**Service information**

**Reference no.:** SDA\_113911\_E97\_G\_B\_HOUSINGPART

**Symptom**

Improved bottom housing does not fit anymore

9965 100 64773 - Bottom housing

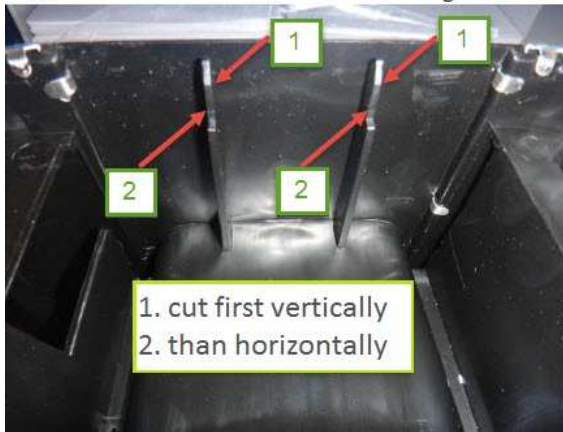
The improved bottom housing part 996510064773 used in HD776x does not fit on top housing part 996510064758 used in HD7761 & HD7762.

Modify (cut 2 rims, see pictures below) bottom housing part 996510064773 to make it fit again on the 996510064758 used in HD7761 & HD7762.
